ENVIRONMENTAL REVIEW TEAM REPORT
ON
WINDHAM HILL
ASHFORD AND WILLINGTON, CONNECTICUT
NOVEMBER, 1973

ENVIRONMENTAL REVIEW TEAM REPORT
ON
WINDHAM HILL
ASHFORD AND WILLINGTON, CONNECTICUT

WINDHAM HILL
PRELIMINARY SCHEME OF DEVELOPMENT
FOR FIRST PHASE

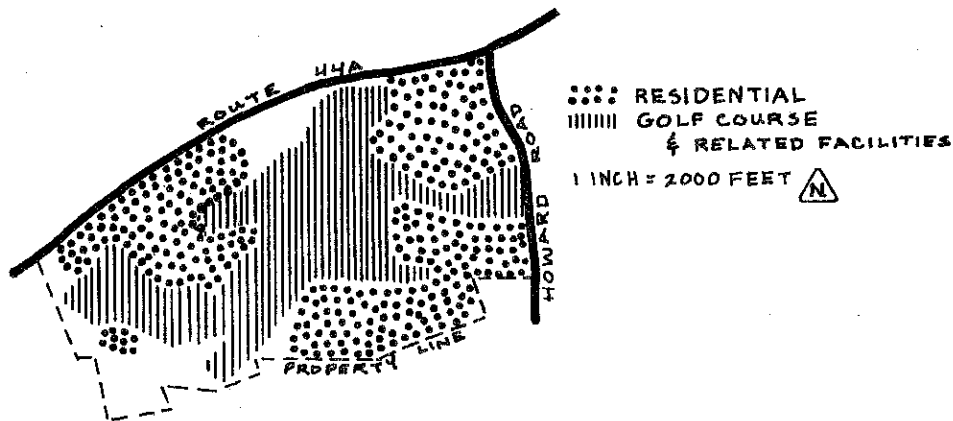
About thirty percent of the soils of the first phase fall under the inland wetlands classification as defined by P.A. 155. The golf course, as proposed, overlaps a substantial portion of this area. Besides the regulatory problems of P.A. 155, the extensive and elaborate drainage system and the fill that would be necessary to establish the golf course present serious questions as to the practicality and economic feasibility of the golf course.

In general, the concept of a combined golf course and residential development appears to be a good one. In this particular case, however, the intensity of development proposed for this site should be reevaluated with respect to its location within a water supply watershed and its relation to substantial wetland areas.

The generation of large amounts of traffic onto Howard Road should be discouraged due to its dangerous intersection with Route 44A. The plan as presently designed indicates that a large number of homes on the Ashford side of the development might be serviced by Howard Road. More convenient access to Route 44A would be preferable.

It does not appear practical or economically feasible to install a golf course as now proposed. A substantial portion of the golf course is located on poorly or very poorly drained soils that are designated as inland wetlands under P.A. 155. To develop a golf course that skirts a wetland could be both feasible and practical, but to develop a golf course through a wetland presents severe drainage and runoff problems that would be costly to correct. It should also be noted that fill over the wetland would also quickly become saturated unless the area is under-drained correctly.

WINDHAM HILL,
FIRST PHASE OF DEVELOPMENT
ASHFORD, WILLINGTON, AND
MANSFIELD, CONNECTICUT

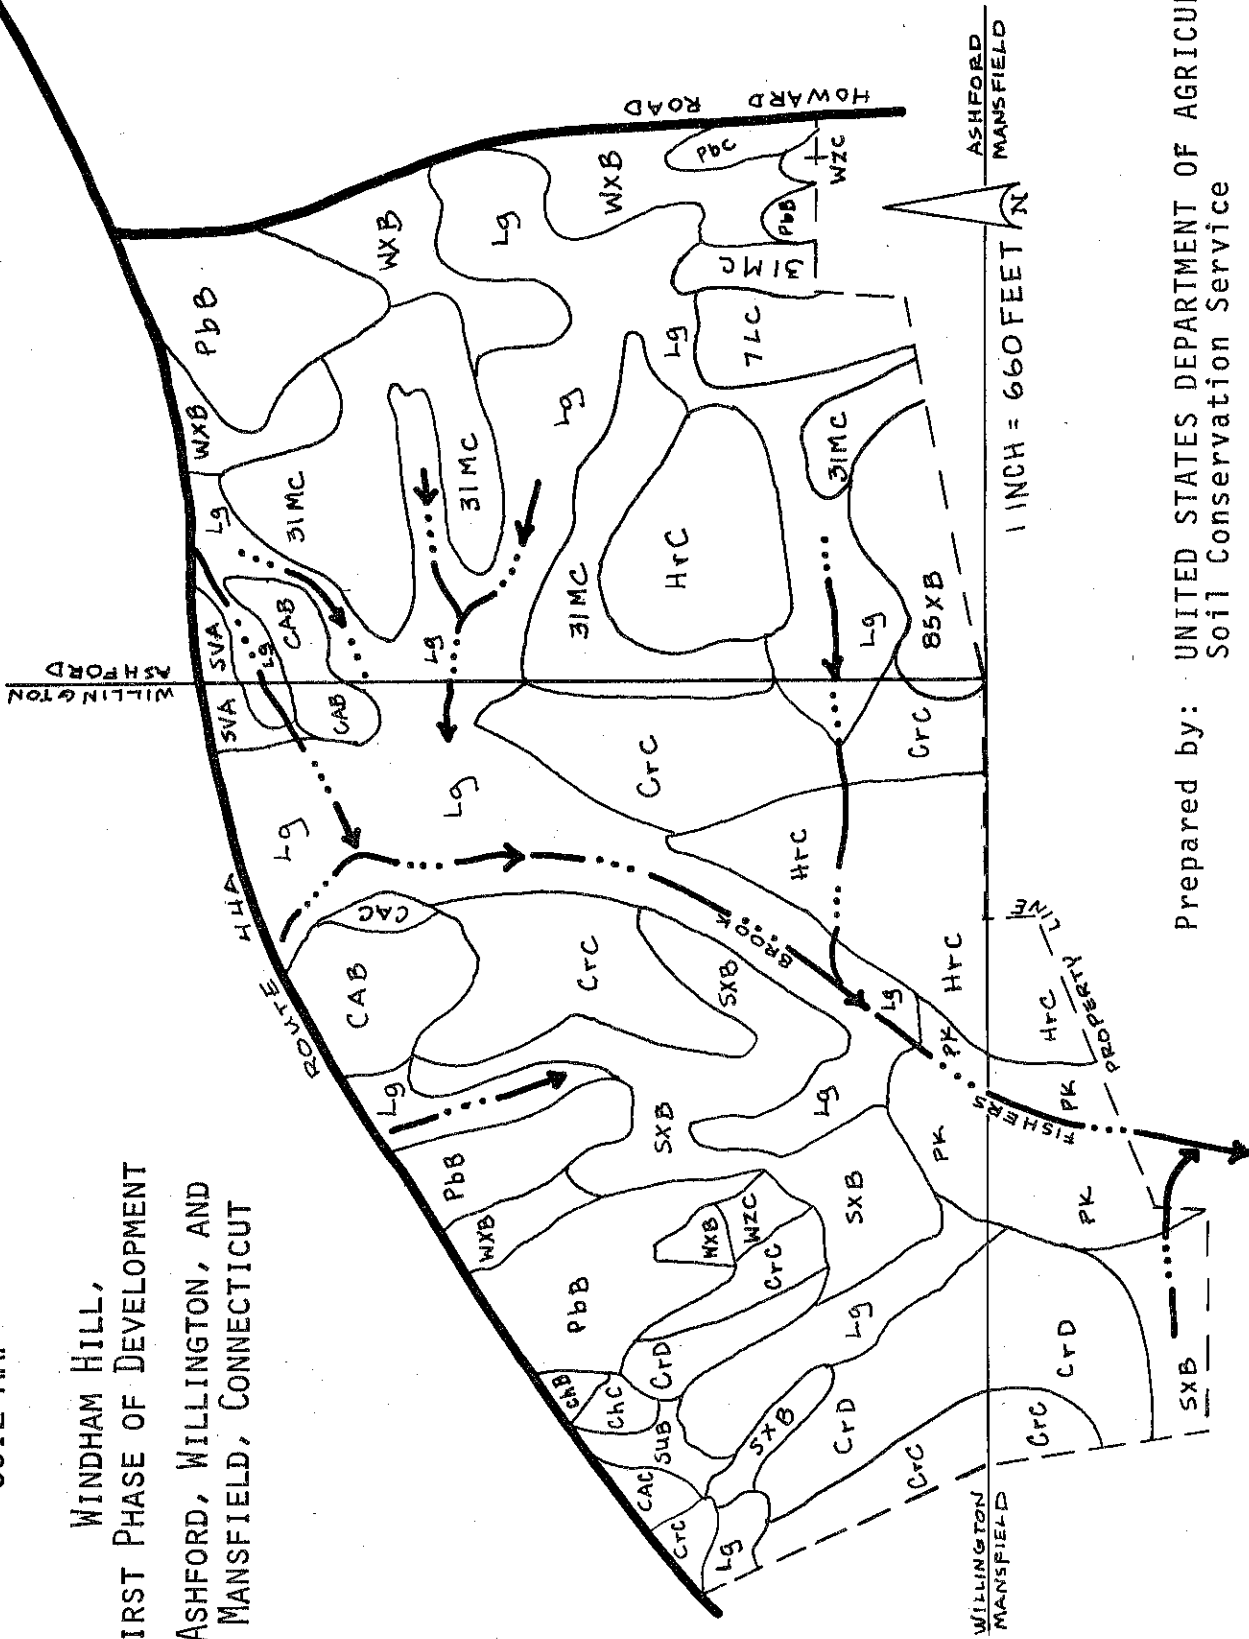
Due to the original scale at which the soils are mapped (1"=1,320'), the lines shown on the map should not be construed as precise boundaries, but rather as guidelines to the distribution of soil types on the property. For purposes of detailed site design, a new survey at a scale more suitable to site design (1"=100-200') would be desirable.

In all probability sewers will not be installed in or near this area for a number of years. Therefore, disposal of domestic sewage will be on-site. Based on the soils map, 30.5 percent of the site has very severe limitations for the installation and operation of septic disposal systems, due to poorly drained soils with a high water table. No systems should be installed in this area.

Another 40.2 percent of the site has severe limitations due to a fragipan, seasonal high water table, and occasional steep slopes and stoniness. Because of the low permeability of the compact tills (fragipan), a curtain drain system would have to be extensive in order to be effective in altering the drainage. Larger lots may need to be considered in some cases to allow adequate space for the location of both the drainage and septic systems, particularly if on-lot wells are also contemplated. With the control of surface drainage and the possible need for filling, the costs of installing these septic systems will be considerably above average.

Based on the soils map, over 60 percent of the area has severe to very severe limitations for the construction of homes with basements. The major restriction is a seasonal or year-round high water table. A considerable amount of drainage would be required to insure against flooded cellars.

Also based on the soils map, over 70 percent of the area has severe to very severe limitations for landscaping (or fairways). The predominant reasons are seasonal or year-round high water table, stoniness, and steep slopes. To render the proposed golf course usable during the normal playing season will require a substantial amount of surface and subsurface drainage.

As indicated by the soils map, 68.5 percent of the area has severe to very severe limitations for construction of streets and parking lots, again due mainly to the wet conditions. Unless adequate drainage is installed, difficulty can be expected not only during construction, but also in future maintenance. Careful attention should be given to interior road specifications by Ashford and Willington to assure that steps are taken to prevent the danger of street breakup and other drainage problems.

Development of any lot will depend on depth to groundwater, fragipan, and/or ledge, and the percolation rate of the soil. It is strongly recommended that a detailed soils map of the property at a scale suitable for design be provided along with observation pits and percolation tests in the areas of the proposed sewage disposal systems. Care should be taken in the location and design of the systems, so as to avoid widespread failure of systems which could adversely affect the Fenton River.
